6.2.3.5. Evaluation of Highway Design Alternatives

6.2.4 Bridge and Road Structure Design

Review for Cost Savings

Figure 6.45. Results of D/D Analysis and Review Analysis (During Construction)

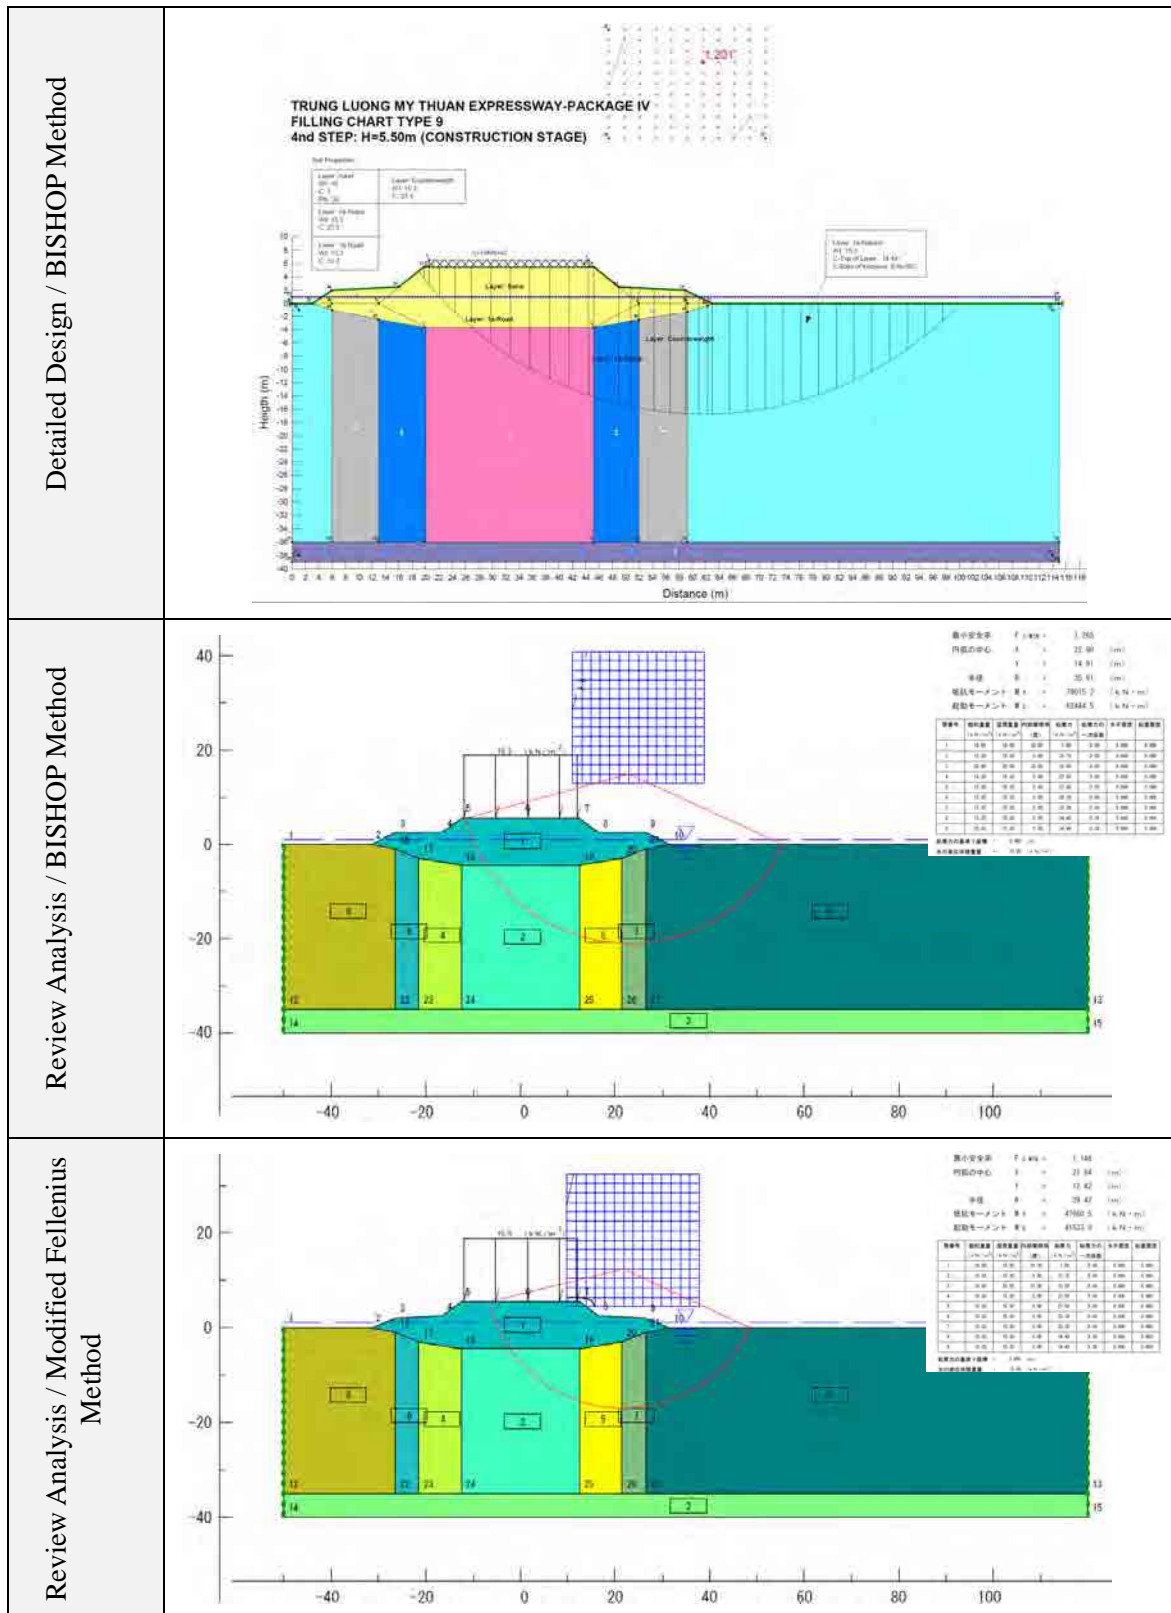
Stability analysis in the detailed design was carried out using the GEO-SLOPE, Bishop method. In this study, this analysis was carried out using COSTANA, Bishop method and modified Fellenius method, which are referred from the "Design Method of Expressway" (H22.7, East Nippon Expressway Co., Ltd. and others). One of the model cases is the Step 4 during construction, and the other is final step after construction. Corresponding results are shown in **Figure 6.45** and **Figure 6.46**. However, slight difference (about Fs 0.05) between the GEO-SLOPE Bishop method and COSTANA Bishop method is observed on each results. Thus, it can be judged that the D/D analysis was reasonably carried out considering that the results are almost the same.

Figure 6.52. Proposed Design Change in PK-12

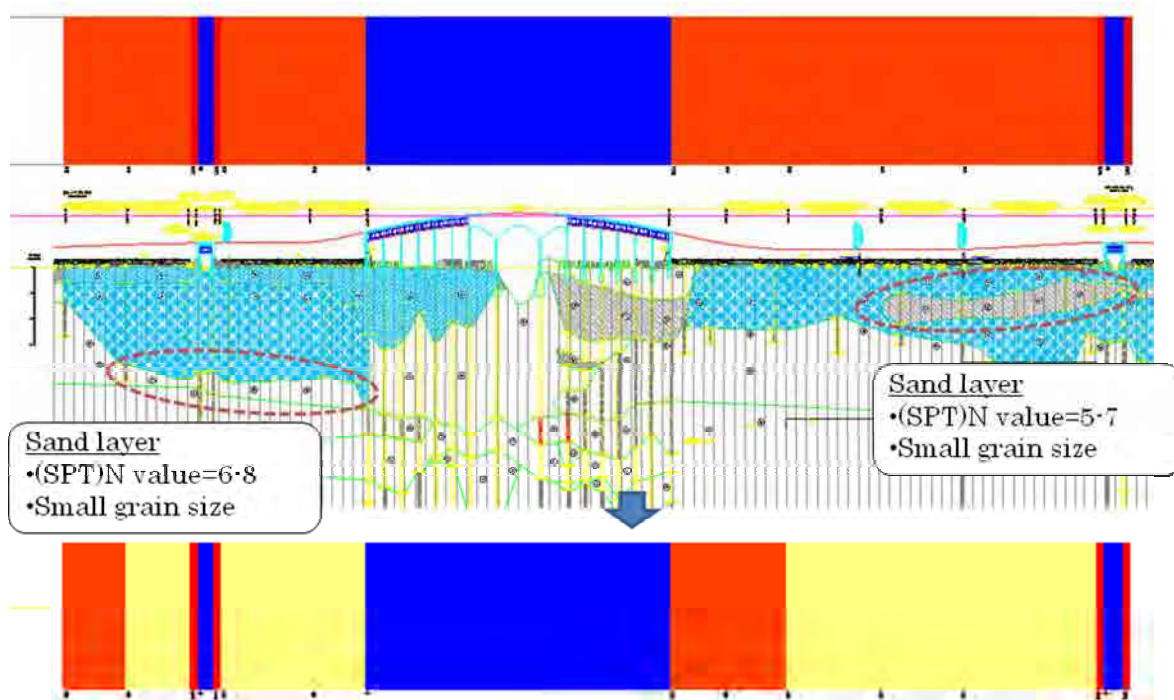
Noting the sand layer's condition in PK-12 and actual performance of PVD machines, PVD can be applied to many sections of PK-12. Therefore, Changing DCM to PVD in some section of PK-12 is recommended as shown in **Figure 6.52**.

- 2) Recommend Alternatives
 - Because the delay of road service will not be tolerated, the application of VCM especially to PK-4 Section 11, which has the highest construction delay risk, is recommended.
 - PVD can be applied in many sections of PK-12. Therefore, changing DCM to PVD in some sections in PK-12 is recommended as shown in **Figure 6.52**.
